MEMORANDUM

From:	Built Heritage Officer		
Service	Green Infrastructure	App No:	242252 + 242253
Address:	Moat House, Biggs Lane, Arborfield, RG2 9LN.		
Proposal:	242252: Full Planning Permission for the change of use of the Moat House building from office (Use Class E) to residential (Use Class C3) to provide 4no. residential dwellings and associated internal roads, parking, landscaping, drainage, plant, bin, and cycle storage. 242253: Application for Listed Building consent for the proposed change of use of the Moat House building from office (Use Class E) to residential (Use Class C3) to provide 4no. residential dwellings and associated internal roads, parking, landscaping, drainage, plant, bin, and cycle storage.		
Heritage Asset:	Moat House – grade II listed building since 2014. Moated site north of Moat House – Schedule Ancient Monument. Listed Buildings and Scheduled Monuments are classed as designated heritage assets under the NPPF (2023) and in the Council’s Local Plan policies.

Existing Plans showing demolition works in red. Blue circled areas being masonry walling nibs expected to be retained.

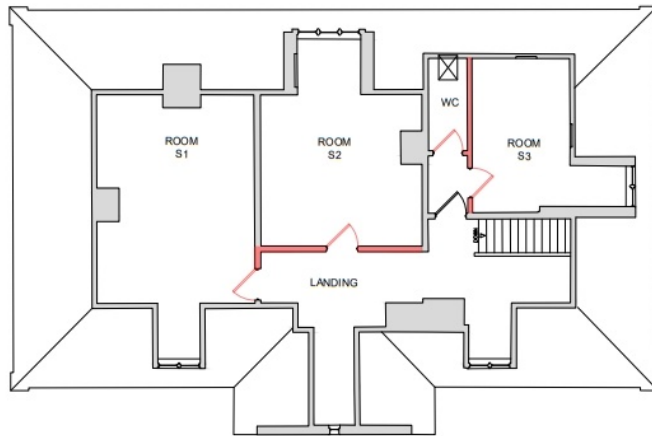
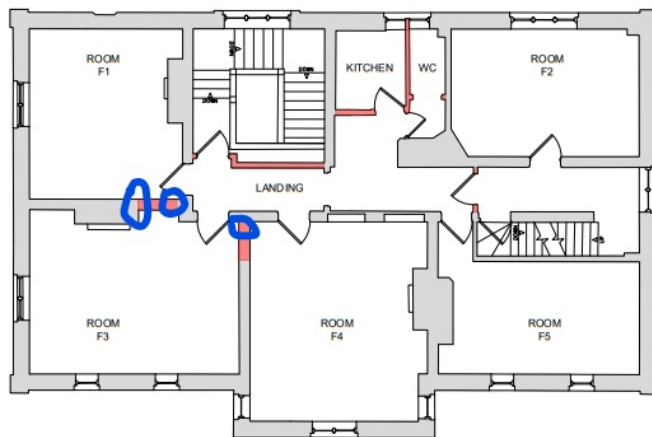
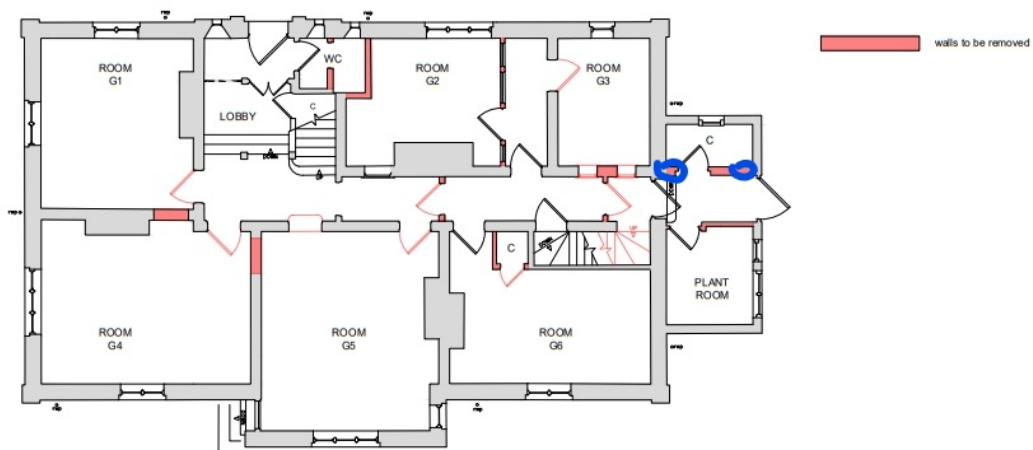
The other issue that it is considered needs addressing is the matter of retaining masonry wall nibs as evidential indication of the original layout of walls in those locations where new openings are to be formed on the first floor and to the kitchen to apartment 2 where an internal masonry wall is to be completely removed.

between rooms are to be formed wall nibs are kept, these are not replicated on the proposed first floor plans. Ensuring the retention of masonry wall nibs where opening between rooms are being formed and where walls are to be removed provide are considered to be important visual indicators of the historic planform of the building. As such, there is the expectation for the proposed floor plans to be amended accordingly.

Notwithstanding the details submitted, where internal walls to be removed and/or new door openings to be formed under this hereby approved scheme, masonry nibs are to be retained, including in the case of new door openings to be formed beside a room fireplace build-out, a small section of the dividing masonry room wall be retained as a 'nib' along with a matching masonry wall nib where the walling dividing the former rooms bisects with the walling of the corridor/hall, unless otherwise agreed in writing by the local planning authority prior to changes being made to the walling.

Proposed Ground & First Floor = blue circles mark location where masonry wall nibs are expected to be retained to delineated historic planform configuration. The yellow encircled element is considered to be an awkward and undesirable intersection of new walling with window (enlarged view below)

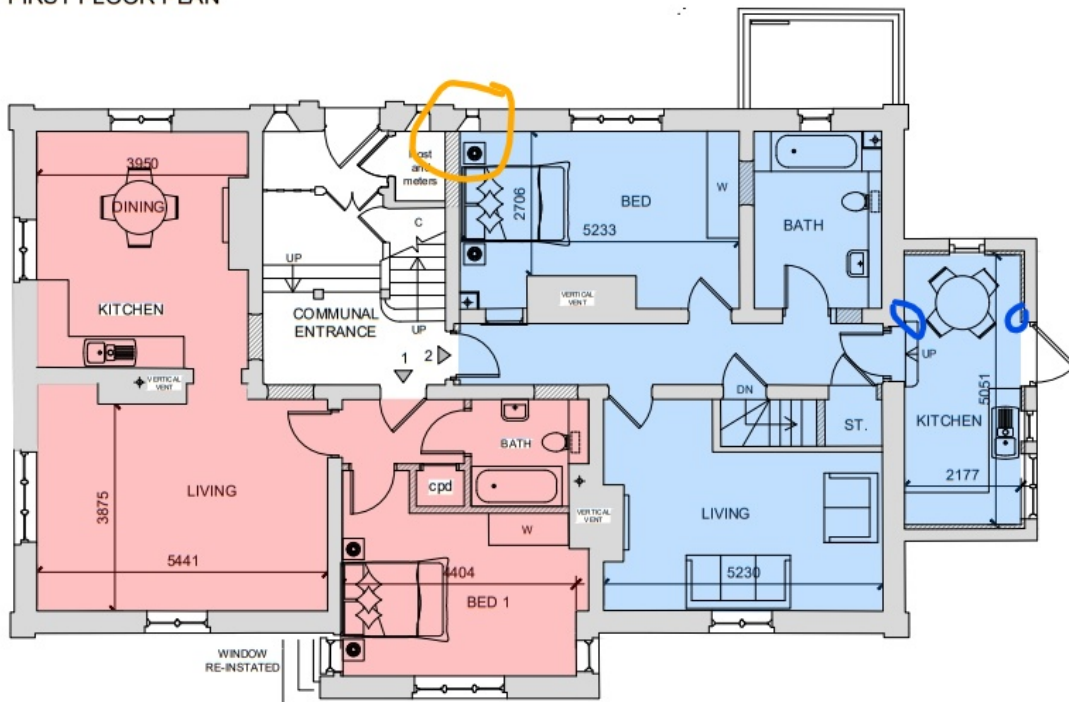
That said, there are elements as proposed, which it is advised require amending in order to better reveal historic elements and to improved evidence of the building's former historic internal layout. To that end, on the ground-floor where there is to be alterations made to the small room off the entrance lobby where new walling is to be introduced to square-off the wall to bedroom to apartment 2's bedroom. This is considered to be a poor arrangement and partially obscure the opening reveal to the lancet window in the exterior wall. It is recommended that the new walling intersection with the exterior wall is amended so as to ensure it does not overlap the window reveal and sufficient space between the wall and window reveal to given to protect the legibility of that window from inside.
